M J Ellison  
Friends of Poynton Pool  
c/o The Civic Hall, Park Lane  
Poynton, Stockport, SK12 1RB

## **Poynton Pool Spillway Upgrade Project error - open letter**

Figure 9.2 Example of a simple F-N plot

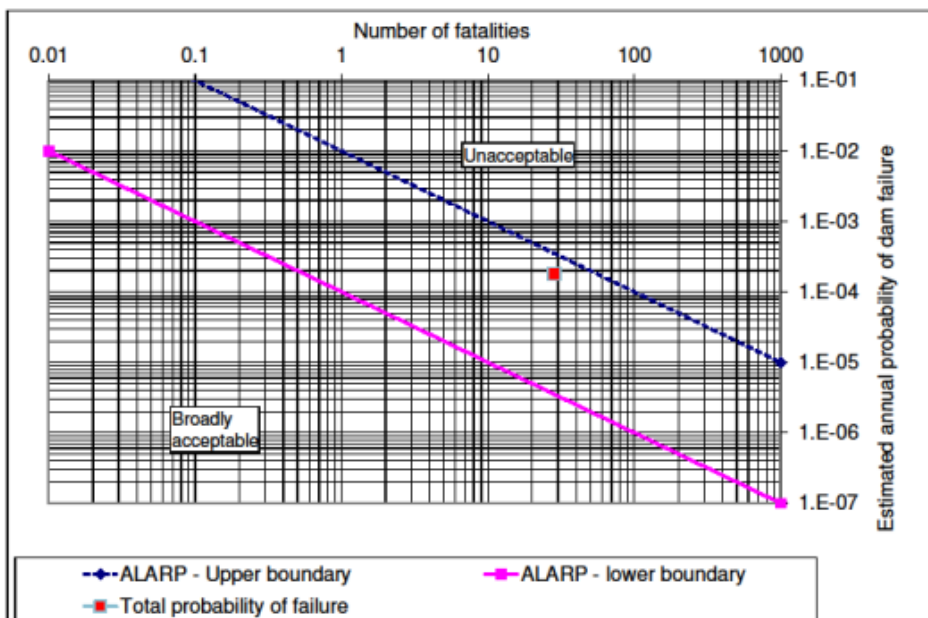
The societal risk point plotted on the F-N chart will fall into one of three categories as divided by the 'ALARP' boundaries in Figure 9.1. This means that the social risk will be classed as being one of the following:

**Figure 2.** Red text and lines added to illustrate the correct positions of the ALARP boundaries as per RARS

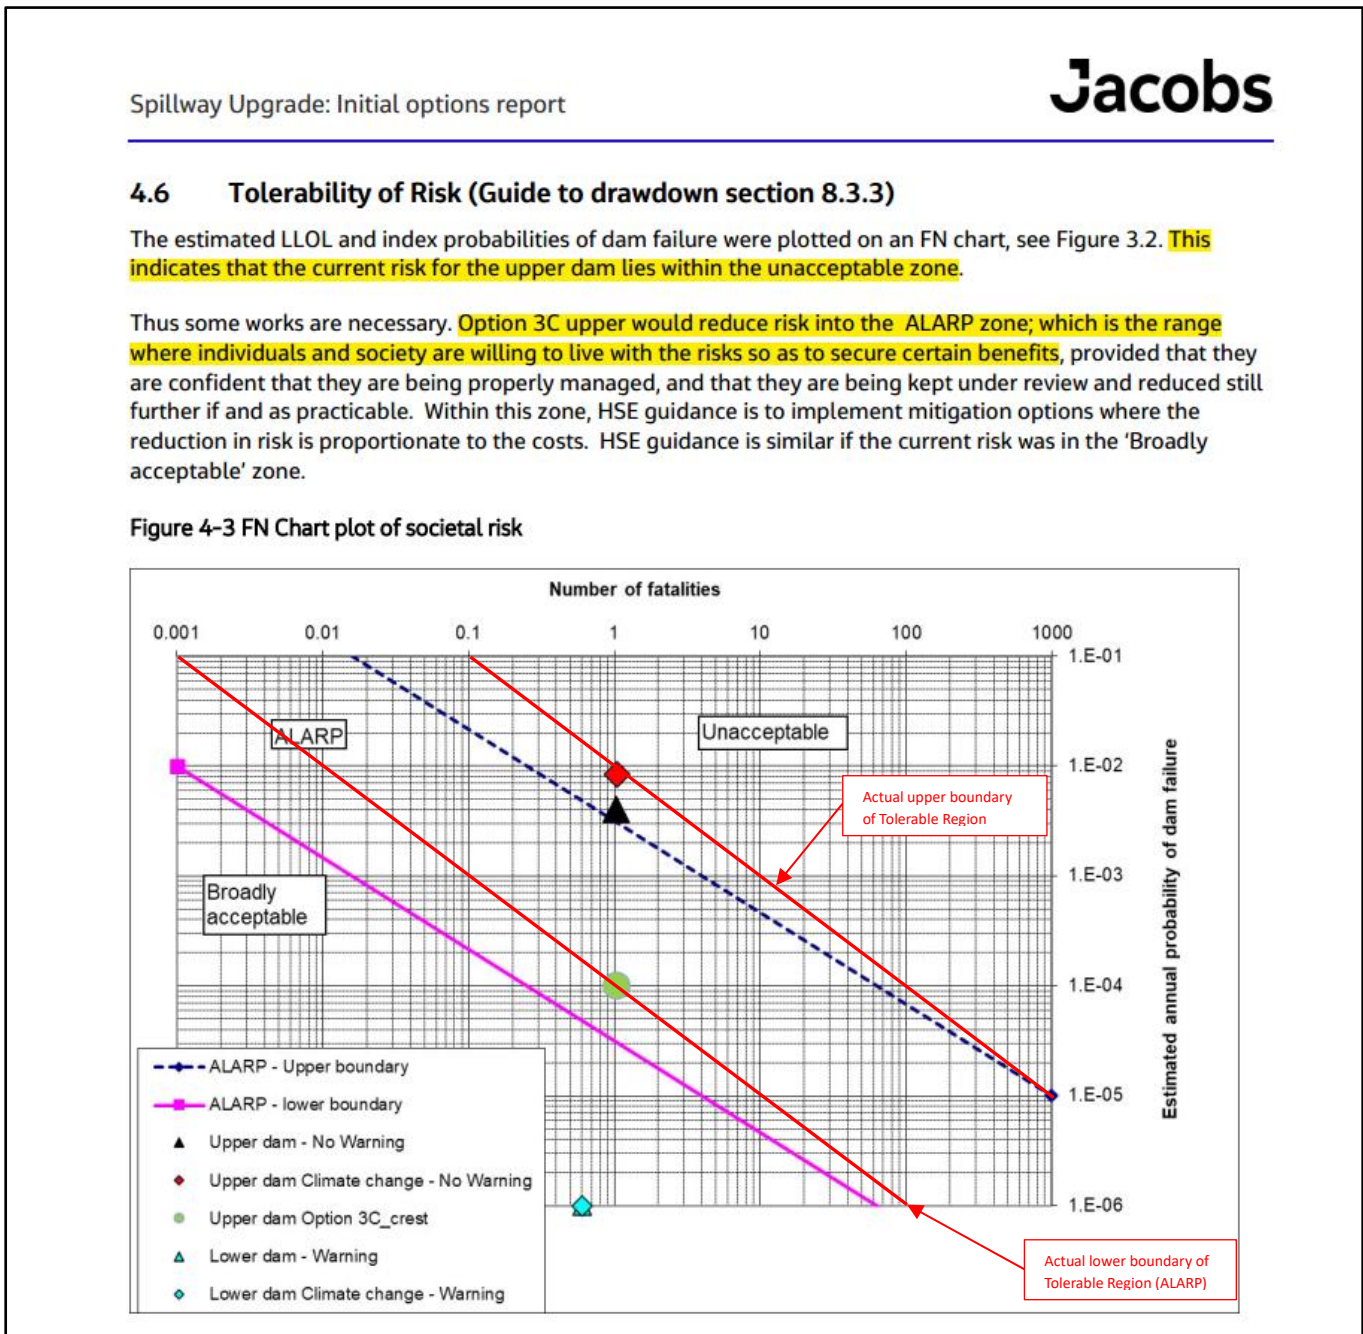
The Executive Summary of the *Initial options report* states "*The current annual chance of failure is estimated as 1 in 250 per year, representing 140mm depth of overflow over the dam crest. When plotted graphically, the level of risk is therefore in the unacceptable zone where works should be carried out to reduce the risk.*"

At 4.6, the report states "*The estimated LLOL and index probabilities of dam failure were plotted on an FN chart, see Figure 3.2. **This indicates that the current risk for the upper dam lies within the unacceptable zone. Thus some works are necessary.***" (my emphasis).

The aforementioned graphical representation from figure 4-3 of the *Initial Options Report* is shown below at figure 2. It uses an F-N chart taken from The Environment Agency's *Guide to risk assessment for reservoir safety management - Volume 2: Methodology and supporting information* (RARS). **The error is that the upper and lower boundaries of the Tolerable Region of Risk (ALARP) are misplotted and when the correct boundaries are used, the plotted risks are NOT in the Unacceptable Region, they are in the Tolerable Region.**

To assist interpretation of the charts, the correct boundary lines are inserted in figure 2 along with notes, all of which are in red.
